**TITLE:** **Hope Street Lots 4 and 8 – Informal Review of  
the Proposed Hotel and Office Development**

The purpose of this Study Session is to present the Robert Green Company's (RGC) preliminary development proposal for Hope Street Lots 4 and 8 and receive direction from City Council on key design topics. The proposed development is still in the early (informal) stages of design review. City Council input is necessary to help guide design revisions and continue the review process. City Council input during this study session is under the role as the land use authority, not as property owner for the public-private partnership for this project.

**Figure 5 – Hope Street Existing Conditions**

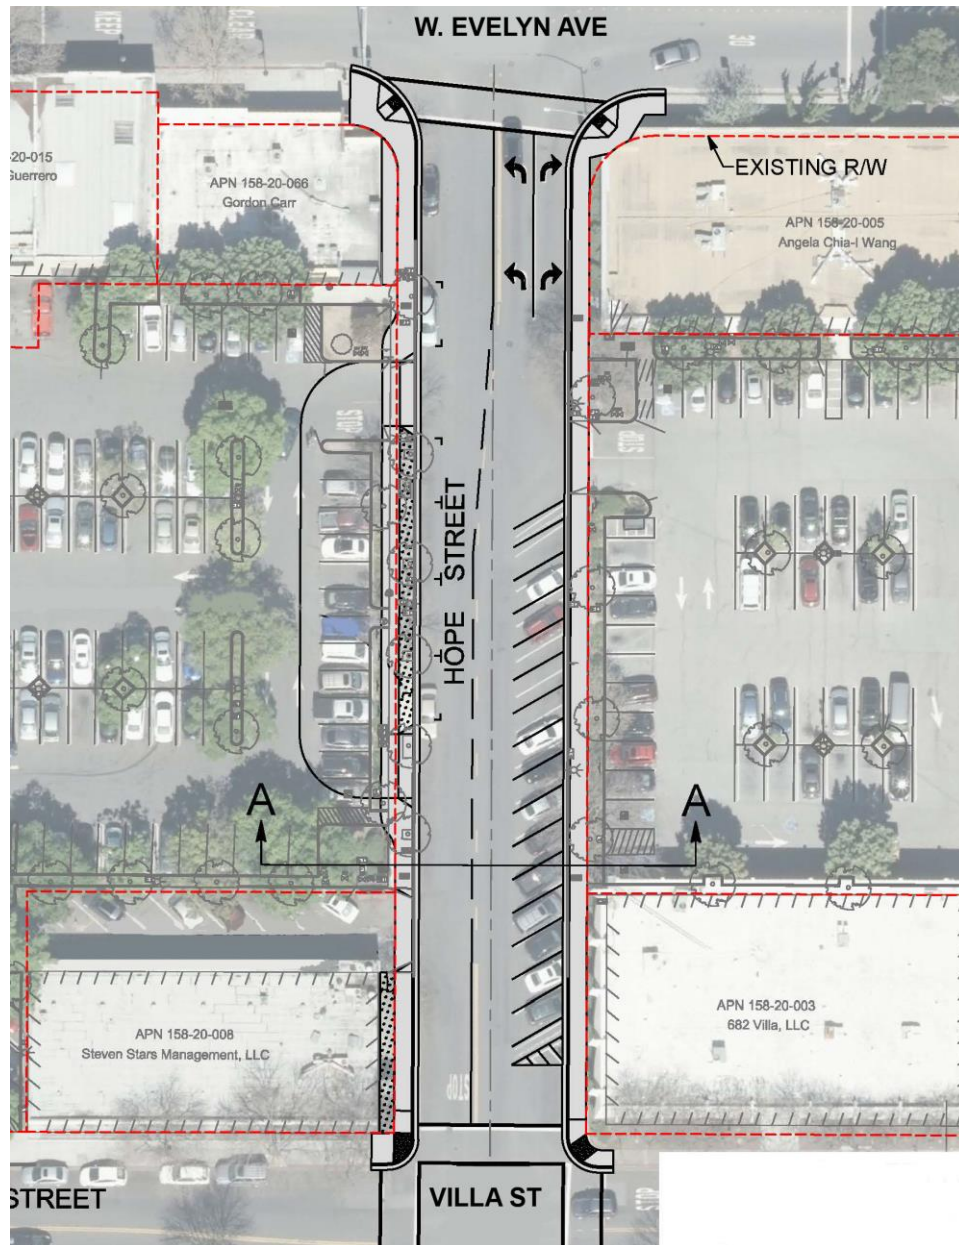
Public improvements on Hope Street are important to achieve the pedestrian-oriented look, feel, and function desired of downtown projects. The proposed streetscape needs to achieve a high-quality pedestrian environment pursuant to the goals of the DPP; address the transportation function of Hope Street, which is an important feeder street to the Downtown Transit Center on West Evelyn Avenue; and provide facilities to accommodate a high volume of pedestrians, bicyclists, and vehicles (buses, shuttles, and private automobile drop-off and pick-up). Existing street conditions are depicted in Figure 5. Improvements for all these various users compete for space within the existing street right-of-way.

**Figure 6 – Hope Street Design and Circulation**

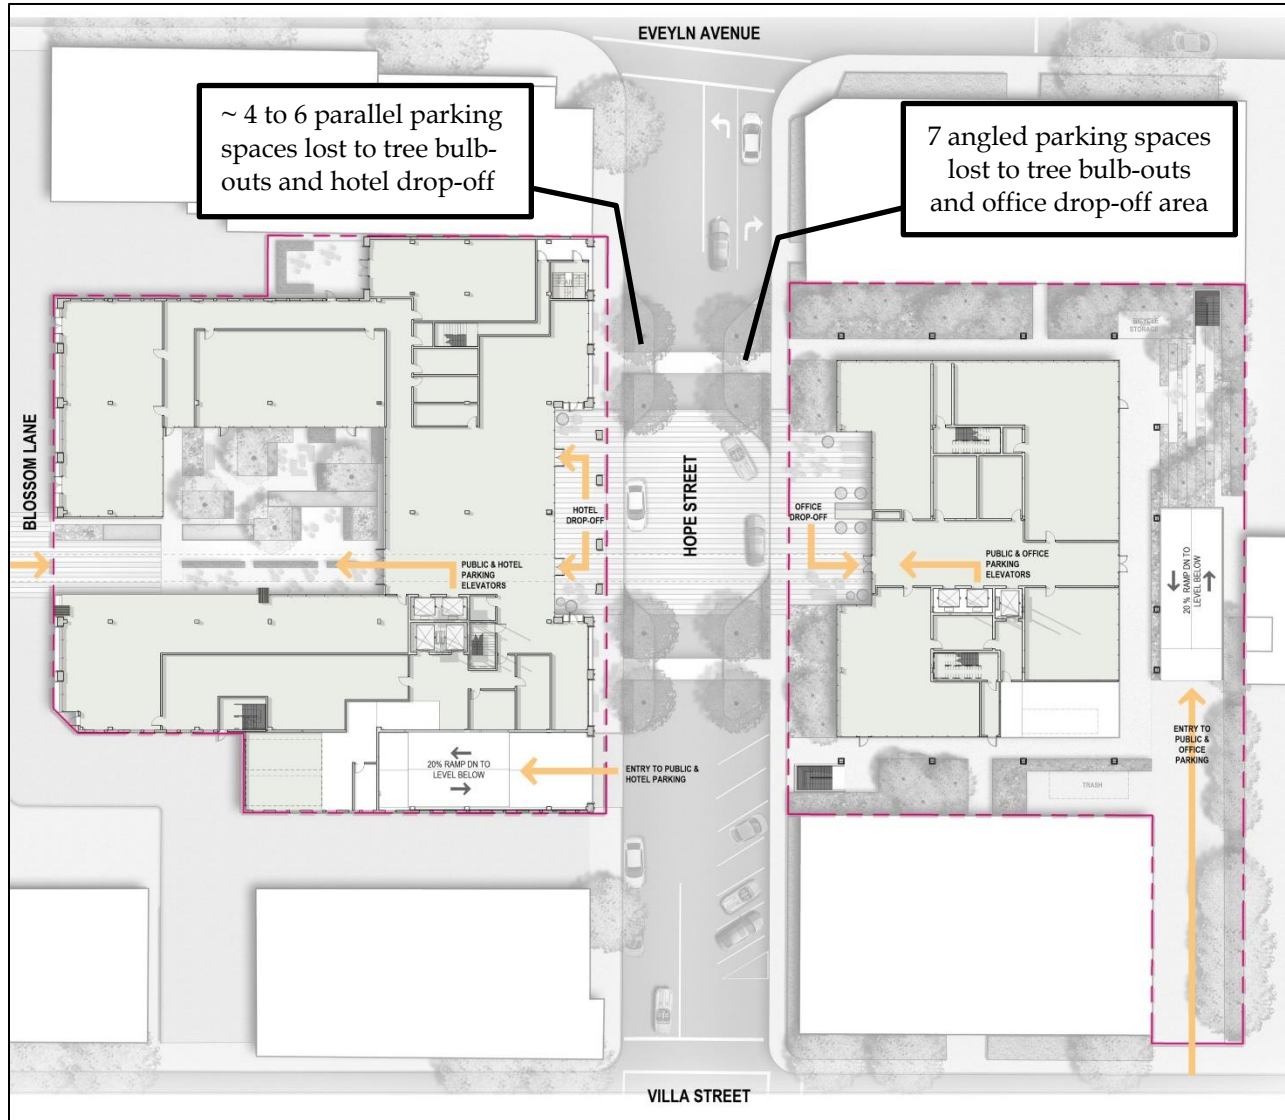
The proposed street design differs from typical public street design in Downtown, and would require removal of some of the existing, 20 to 22 parking spaces on this portion of Hope Street (14 angled parking spaces and six to eight parallel parking spaces). With the applicant’s proposed street design, approximately seven to nine on-street parking spaces would remain. Staff recommendations on Hope Street design are discussed below.

Staff agrees there is value in using special design strategies to create a strong visual and physical connection between public parking areas and the greater downtown area. The proposed special paving materials are not typical to Downtown or consistent with City standard street design, and would have increased costs and can present unique maintenance issues for the City over the long term. As such, staff is typically not supportive of such proposals in the public right-of-way; however, due to the linked public parking uses on both lots, the use of specialized materials around the mid-block crossing might be an appropriate exception if the Council supports this strategy knowing the costs and challenges for installation, maintenance, and future materials replacement.

If special materials are not supported, this does not preclude the project from creating a Hope Street mid-block crosswalk—like other locations in the downtown—that strengthens the connection between new public parking and downtown destinations. Staff recommends further exploring the use of specialized crosswalk design/materials, and *creating a single mid-block crossing* that is better aligned with the main building entries and the linear connection from Castro Street, instead of two mid-block crosswalks that are offset by the current location of the passenger drop-off zones. Consolidation into a single mid-block crossing could help reduce the loss of on-street parking spaces than the two proposed crossings.

Given the existing property line locations and proposed building design, much of the frontage only maintains the existing Hope Street sidewalk width (approximately 6') clear of any obstructions. Staff recommends a minimum continuous sidewalk width of at least 10', if not wider, with street trees and no buildings overhanging above.

- *Transit/Vehicle Improvements:* As other improvements are made, the street will need to maintain facilities for vehicles. This includes adequate lane width to accommodate buses and shuttles; community members have also highlighted a priority to preserve on-street parking. The applicant has proposed visitor drop-offs in front of both the hotel and office; while staff feels some sort of drop-off may be appropriate for the hotel use, *a drop-off in front of the office is not recommended.*

***Question No. 4: Does Council support a new mid-block crossing across Hope Street, and staff's recommendation on design, materials, and details?***

**Figure 7—Hope Street Section with No Sidewalk Widening**

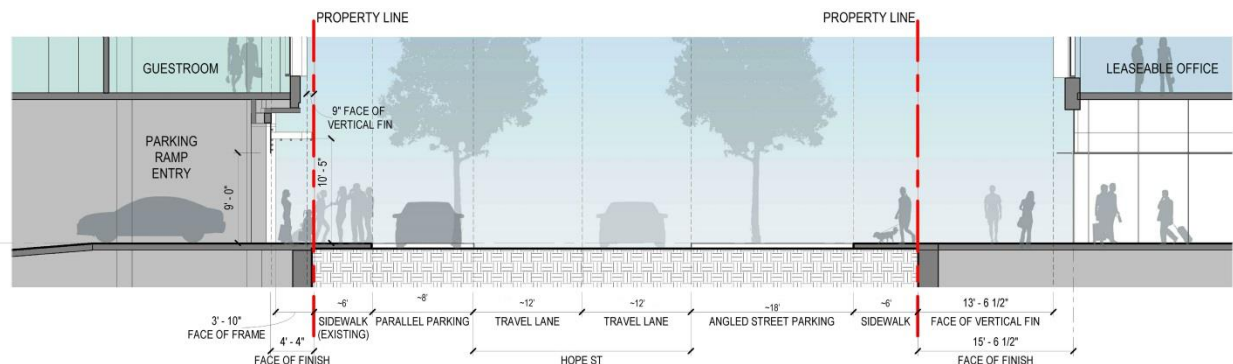
Alternatively, the Council may not agree with staff's prioritization of widening the Hope Street sidewalk and other non-vehicle improvements, and instead opt to maintain the existing on-street parking as the highest priority. This would not change the Hope Street roadway and pedestrian conditions present today -- 6' sidewalk clear to the sky, no mid-block crossing, no hotel or office drop-off areas, but will include the addition of the proposed hotel and office buildings (see Figure 7).

Staff supports a wider sidewalk of no less than 10' and believes the loss of some, but not all, on-street parking is a worthy trade-off if the end result is a comfortable but efficient pedestrian-oriented streetscape.

***Question No. 5: Does the Council support staff's prioritization of streetscape features along Hope Street, despite potential impacts to on-street parking? Does Council want staff to study the option of dedicated bicycle facilities on Hope Street at the expense of additional on-street parking?***
